IMPROVEMENT PERMIT DENIAL

Re: Application for improvement Permit for property located at 9606 Beatties Ford Rd, 01546150

Health Department file #12065B

SOIL/SITE EVALUATION
for ON-SITE WASTEWATER SYSTEM

PROPOSED PLOT PLAN

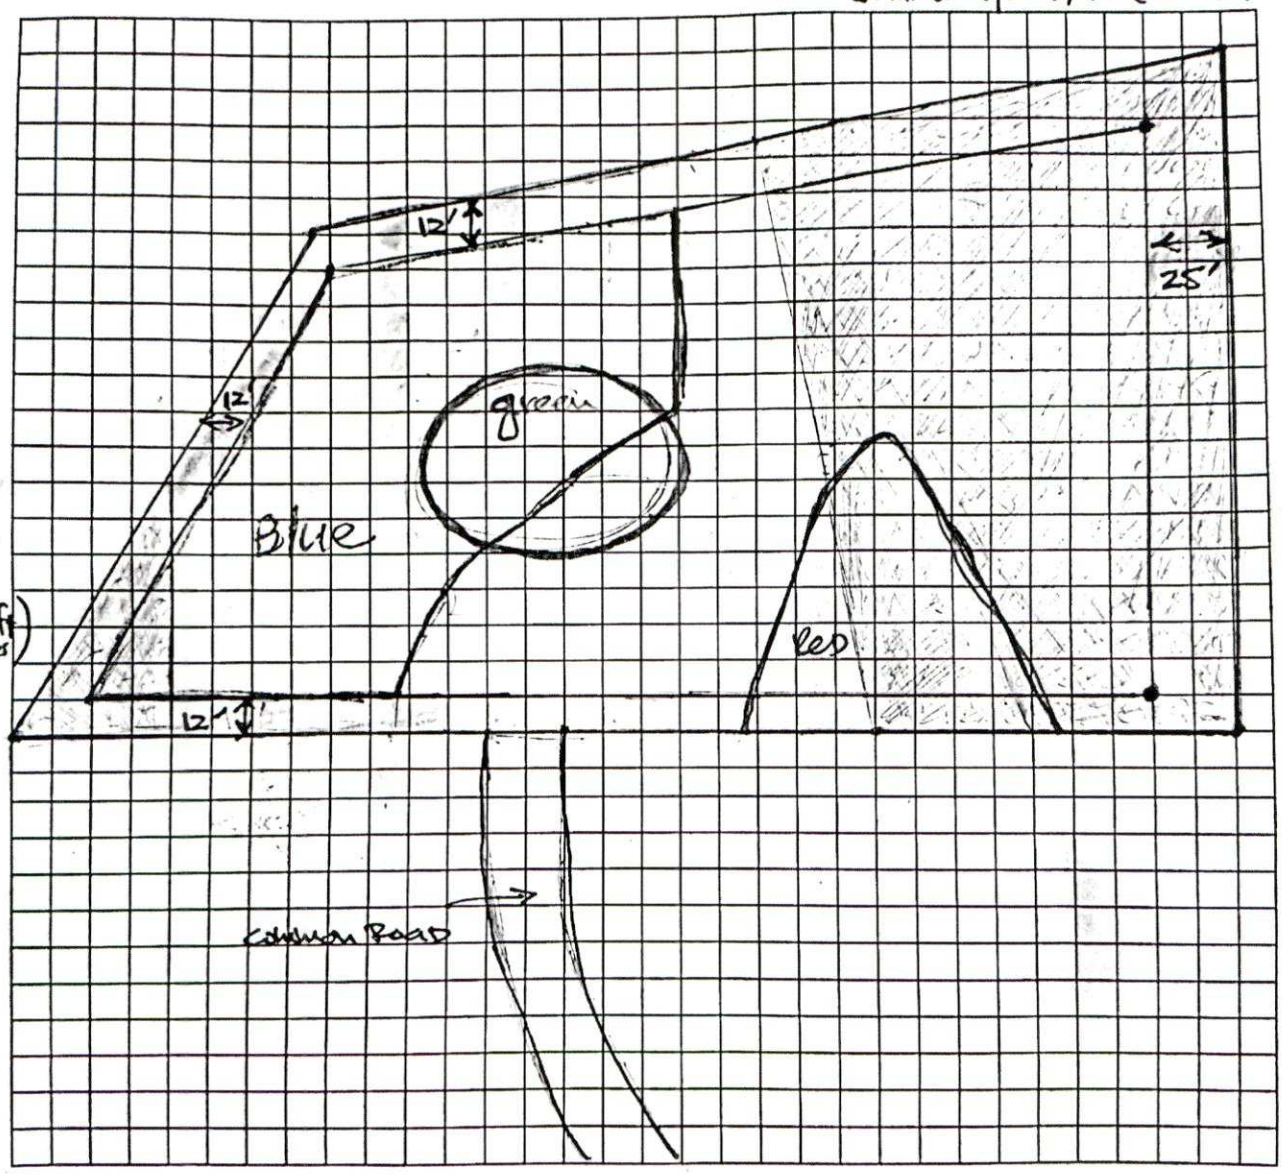
Based on the criteria set out in 15A NCAC 18E .0501 through .0602, the evaluation indicated that the site is **UNSUITABLE** for an on-site wastewater system. Therefore, we must deny your request for an Improvement Permit. A copy of the site evaluation is enclosed. The site is unsuitable based on the following:

- ☒ Unsuitable soil topography and/or landscape position (Rule .0502)
- ☐ Unsuitable soil characteristics (structure or clay mineralogy) (Rule .0503)
- ☐ Unsuitable soil wetness condition (Rule .0504)
- ☐ Unsuitable soil depth (Rule .0505)
- ☐ Unsuitable saprolite (Rule .0506)
- ☐ Presence of restrictive horizon (Rule .0507)
- ☒ Insufficient space for septic system and repair area (Rule .0508)
- ☐ Unsuitable for meeting required setbacks (Rule .0601 or .0602)
- ☐ Other (*Cite applicable rule*):_____

The site evaluation included consideration of possible site modifications, as well as use of all possible systems approved under 15A NCAC 18E. However, the Health Department has determined that none of the above options will overcome the severe conditions on this site. A possible option might be a system designed to dispose of sewage to another area of suitable soil such as off-site to additional property.

Soil & Site Evaluation Map

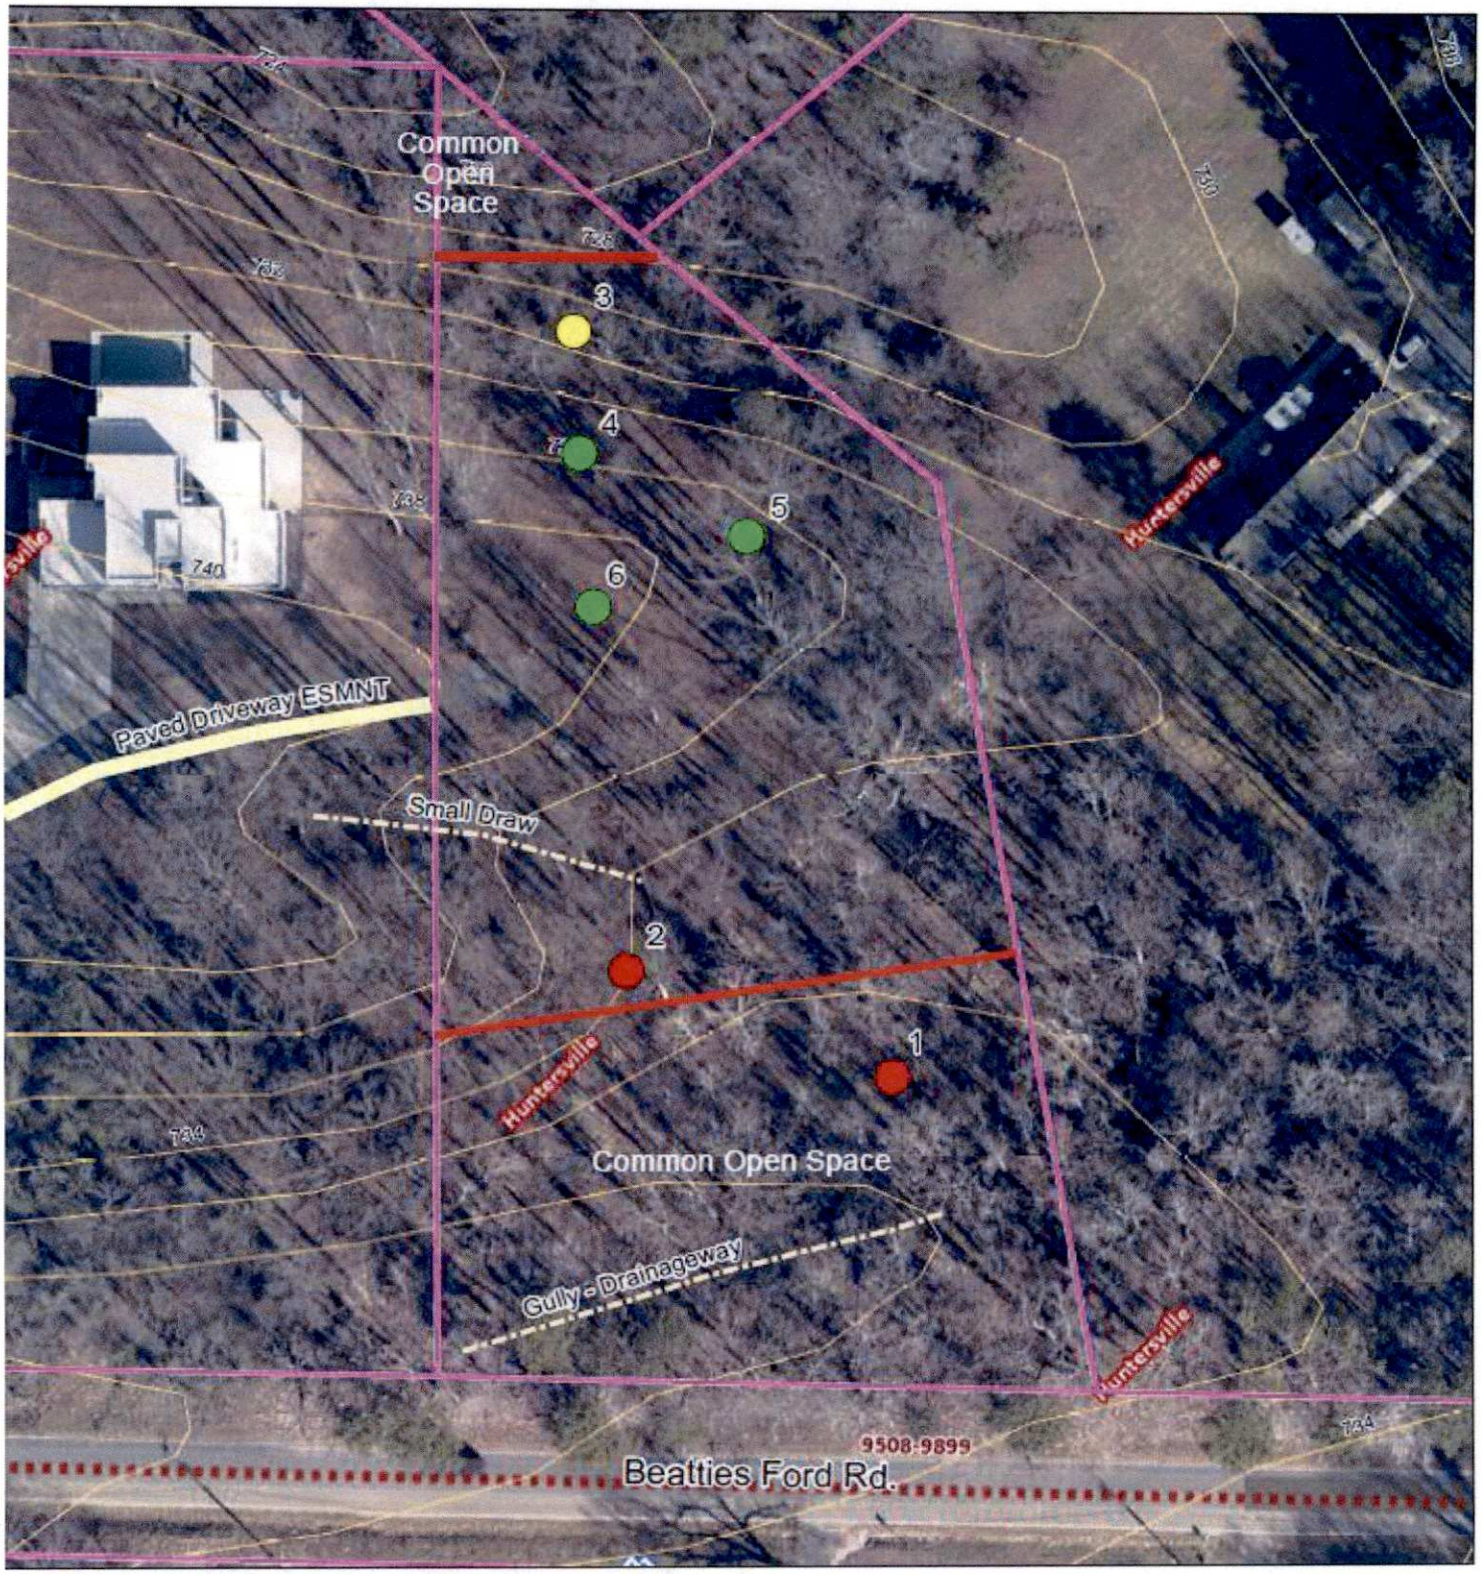
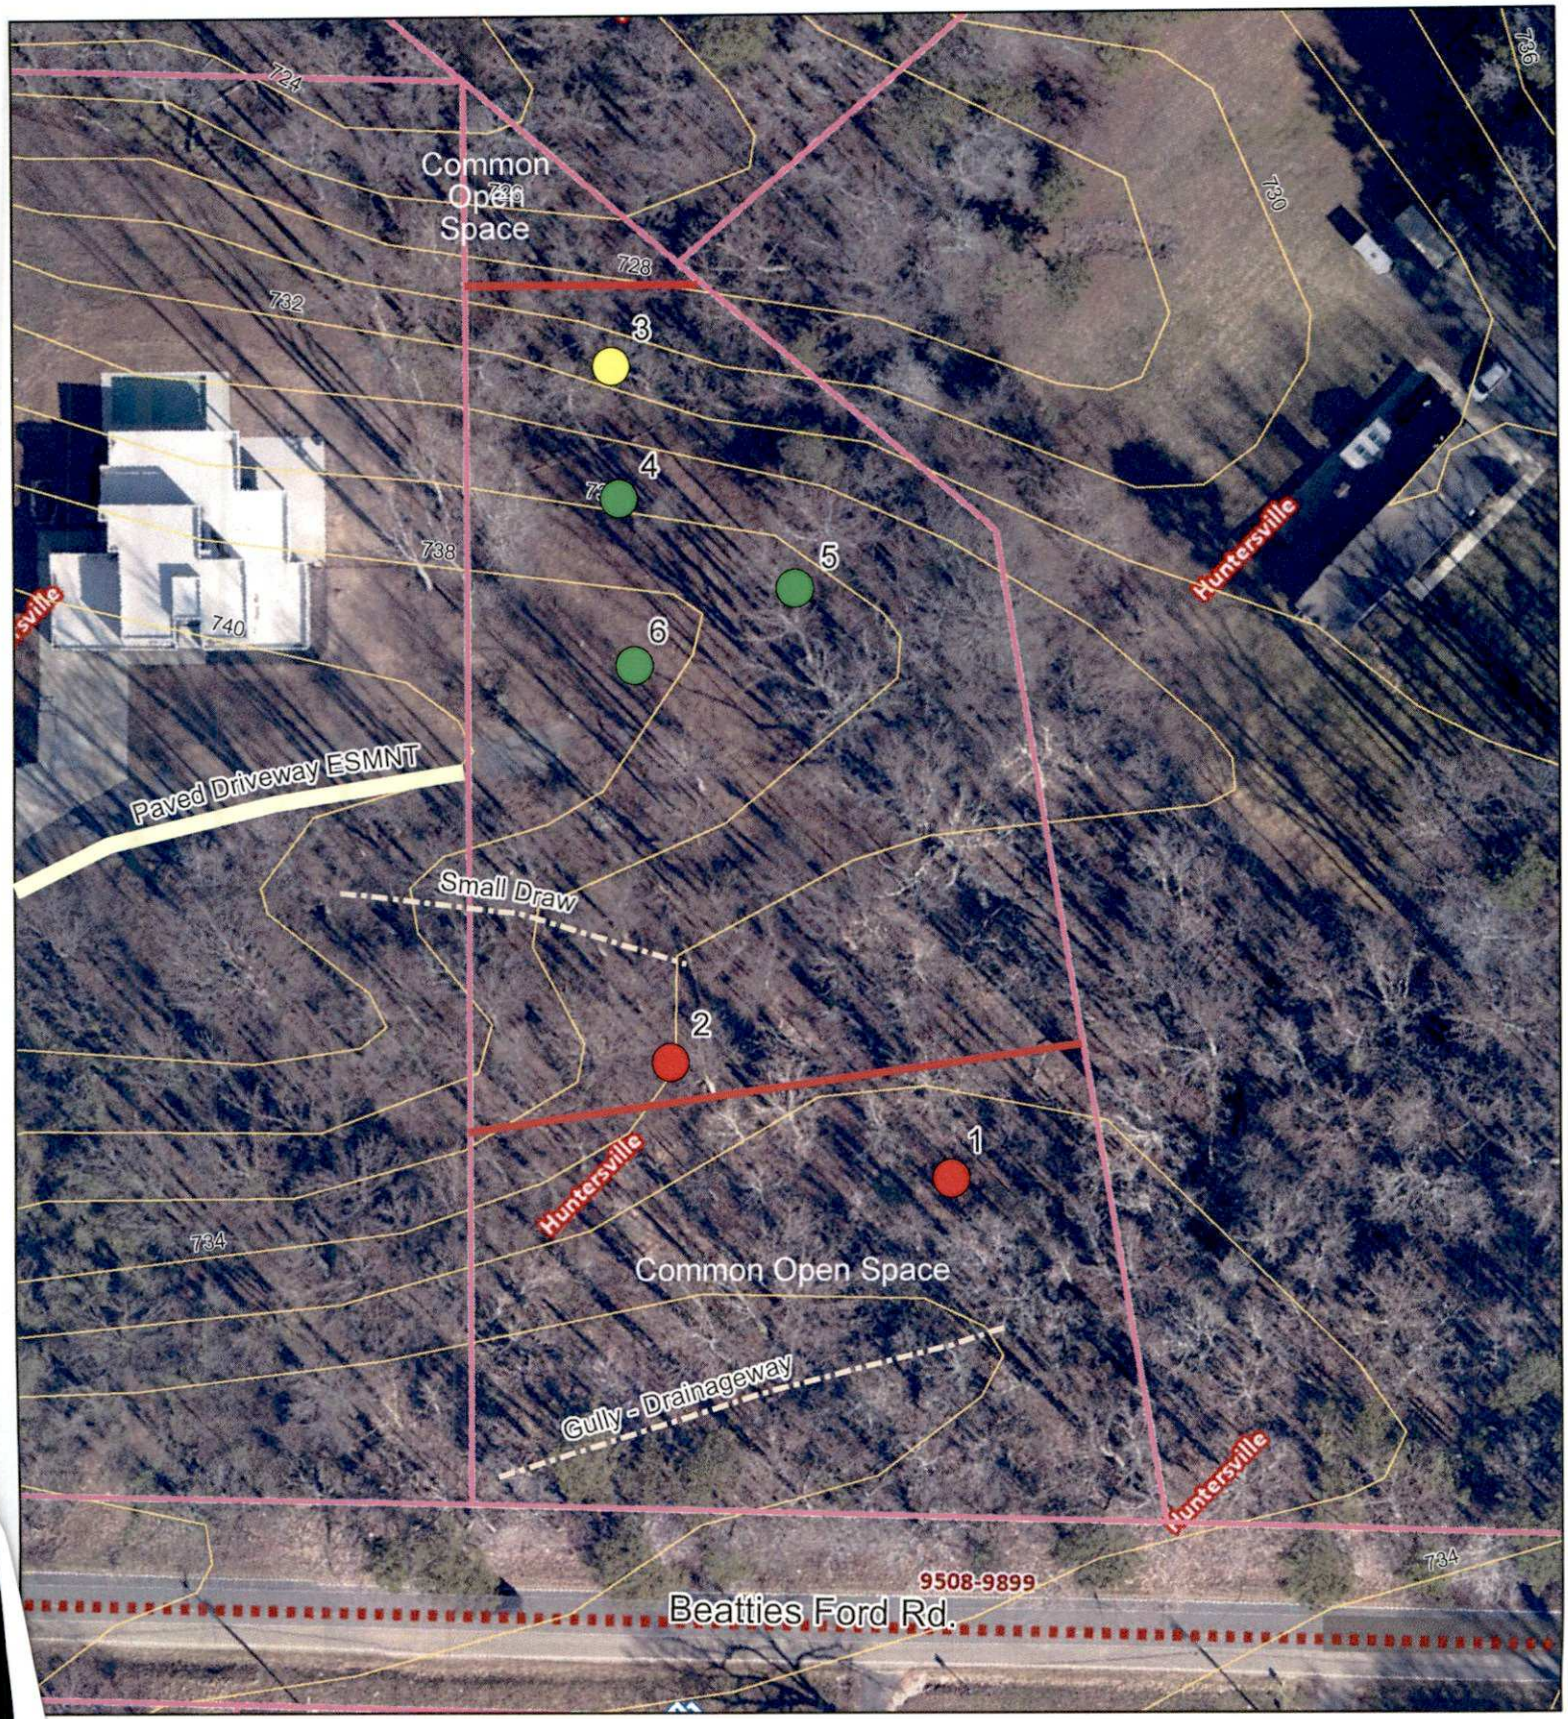
COMMENTS: The locations and dimensions of the home, the 3-4 car garage, and the pool not known nor are they marked in the field. Suitable soils and topography limited to the areas of soil borings #3 - #6. Their preferred septic area would need to be a drip, LPP, or other shallow placed engineered system.
